BLUE BIRCH 1447 NW 65TH ST

DESIGN RECOMMENDATION PACKET
13 June 2022
SDCI Project #3036782-LU

RESPONSE TO BOARD RECOMMENDATION

(FINAL RECOMMENDATION OF THE NORTHWEST DESIGN REVIEW BOARD, 04.02.2018)

HEIGHT, BULK, SCALE - SETBACKS

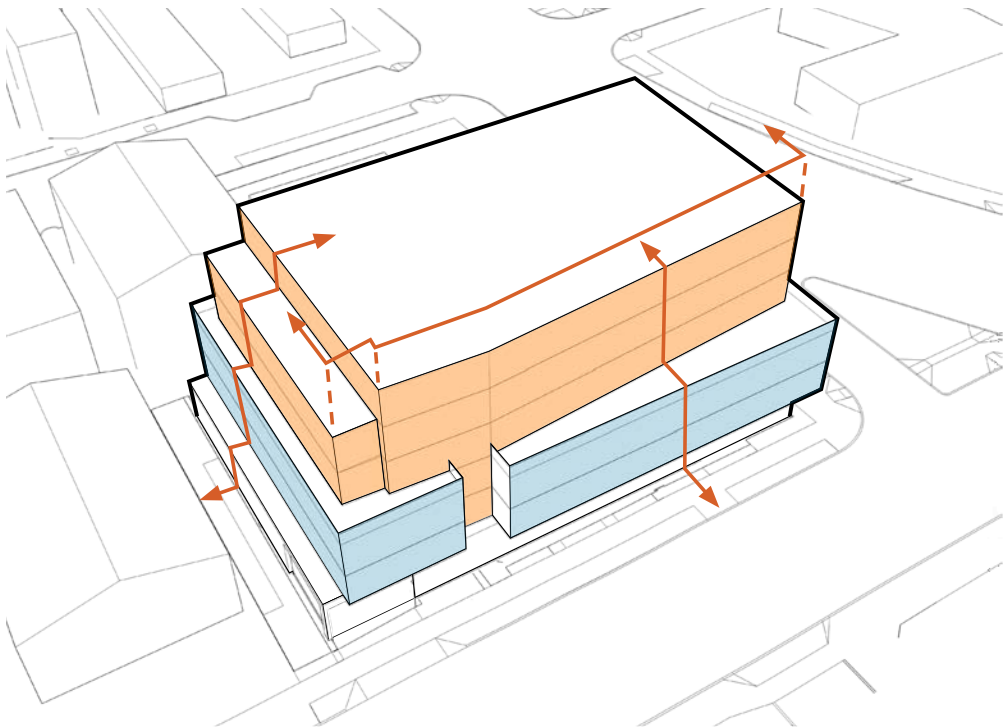
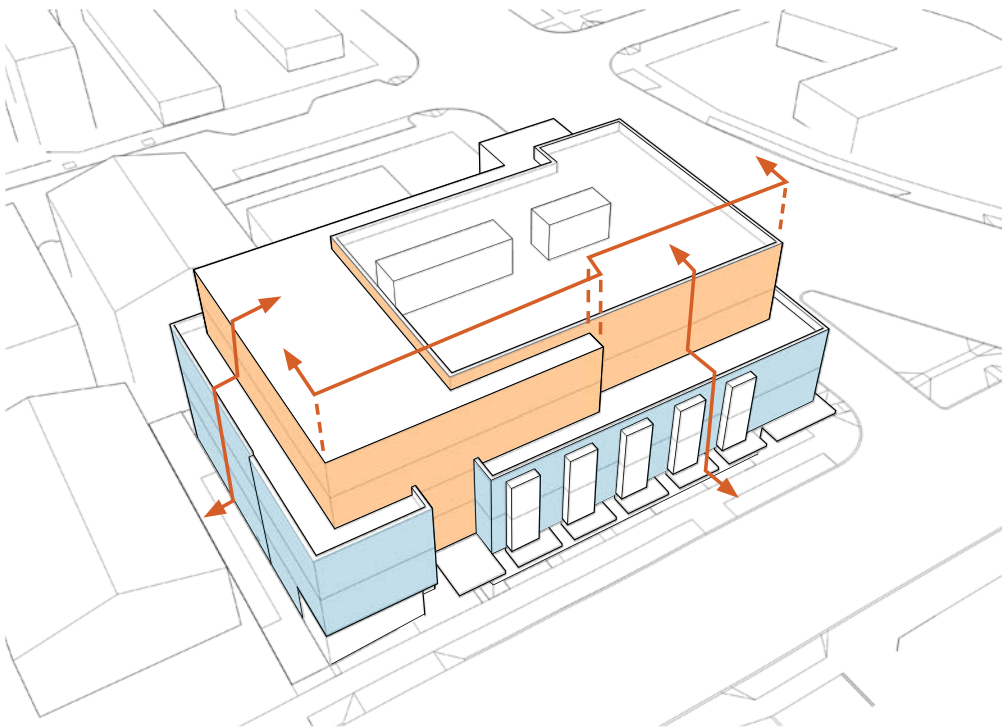
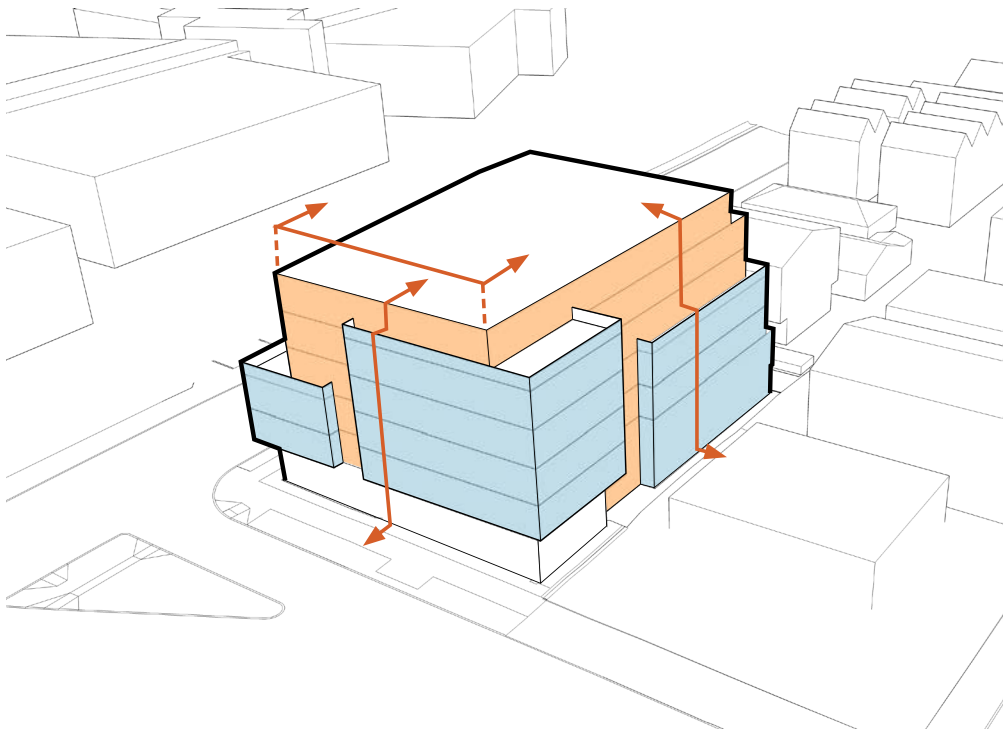
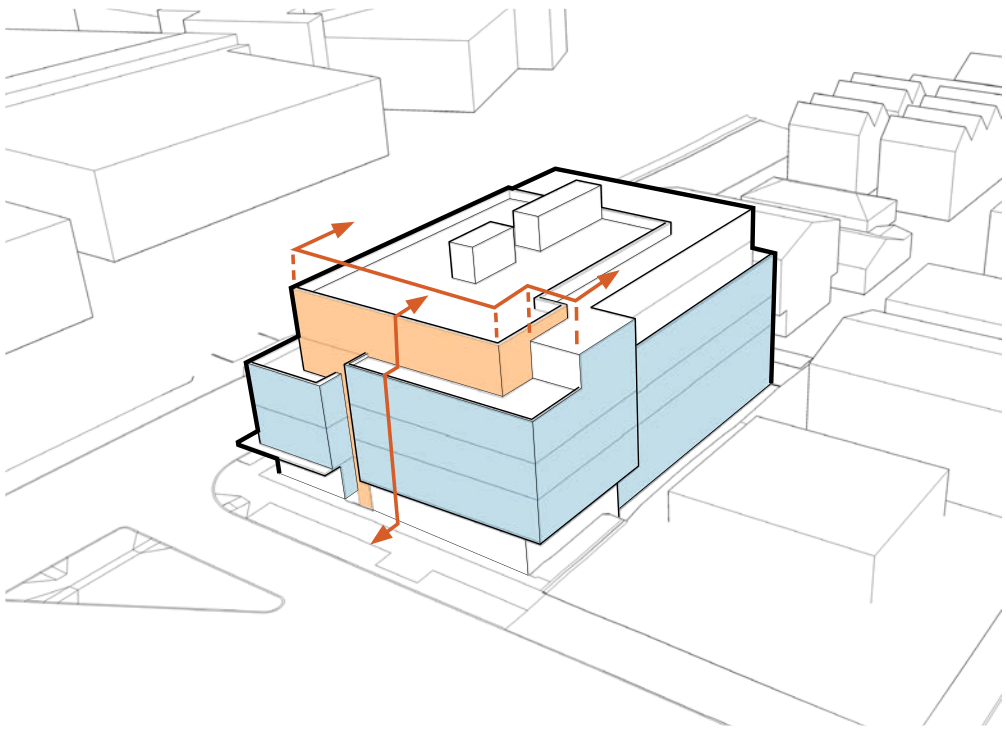
- a. The proposed project does not relate to the context of the surrounding sites and is too tall. (CS2.D.3 & 4)
- b. More relief should be provided at the zone edge by stepping the building and setting back the upper floors. (CS2.D.1, 3, 4 & 5)

- a. The building has been revised to 5-stories, rather than the previous 6-story proposal. The 3-story massing along NW 65th St relates to the scale of Ballard High School. The windows at the bay windows provide similar scale to the high school windows.
- b. The massing has been simplified to comply with the MHA 55' zoning setback requirements. The building is permitted to be 10' from the LR zone up to 65'. The 4-5 floors are setback 16' to provide additional relief.

LR TRANSITION - EAST ELEVATION

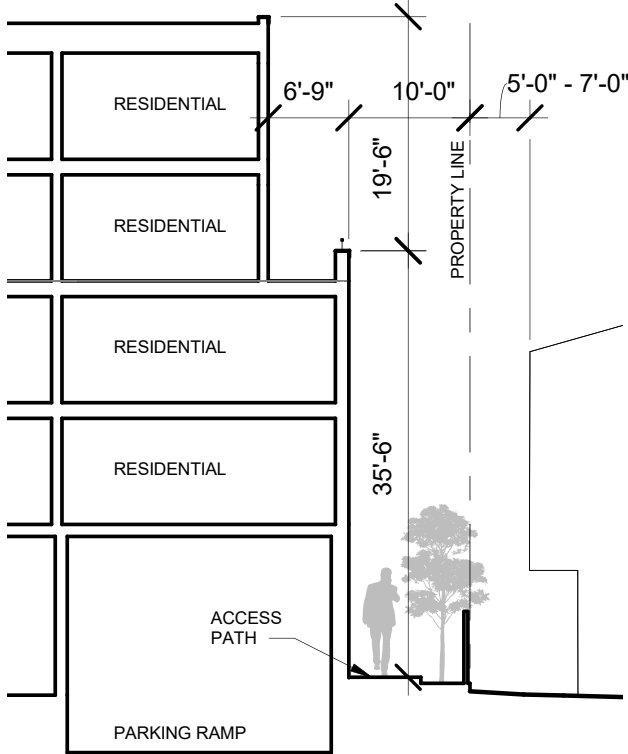
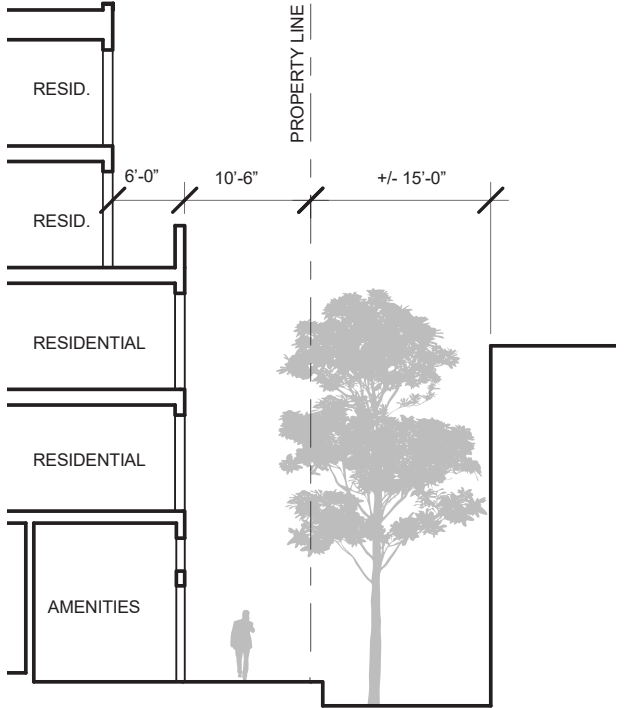
- b. Provide more relief at the zone edge by stepping the building and setting back the upper floors. (CS2.D.3&4)
- i. The roof amenity area should be configured away from the LR zone and focus the active rooftop uses at the SW corner. (CS2.D.5)

- b. The building has been revised to 5-stories, rather than the previous 6-story proposal. The 3-story massing along NW 65th St and the east property line relates to the scale of Ballard High School and the context in the LR zone. The massing has been simplified adjacent to the LR3 zone with the reduction of 1-floor and complies with the MHA 55' setback requirements. The building is permitted to be 10' from the LR zone up to 65'. The 4-5 floors are setback 16' to provide additional relief.
- i. The roof amenities area has been configured to the west and southwest portions of the roof as identified on the roof plan.
